**CITY COUNCIL MEETING
JOHN GREEN
SITE PLAN- METAL STORAGE BUILDING
1700 EAST ANVIL ROAD
JUNE 15, 2017**

NOTES- John is planning to build a metal storage building for his snow removal equipment, hardware, and misc. building repair items. This will be a good addition for his operations in this area. This site plan location is behind the west end of the second building on Anvil road, inside the current fenced area. The Planning Commission recommends approval with the conditions of using dark sky lighting & maintaining a weed control plan.

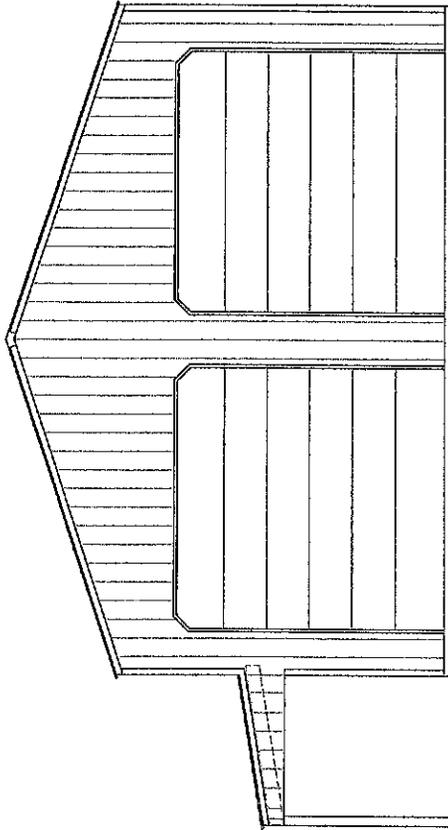
FENCING- There is an existing chain link fence.

LANDSCAPPING- In this location, behind the building, there probably is not a need for further landscaping. They should have a plan to keep the weeds down around the building.

LIGHTING- Some on the building- Two existing pole lights

STORMWATER- There should be sufficient area existing around the building to handle the storm water from this building. The drainage is very good in this area.
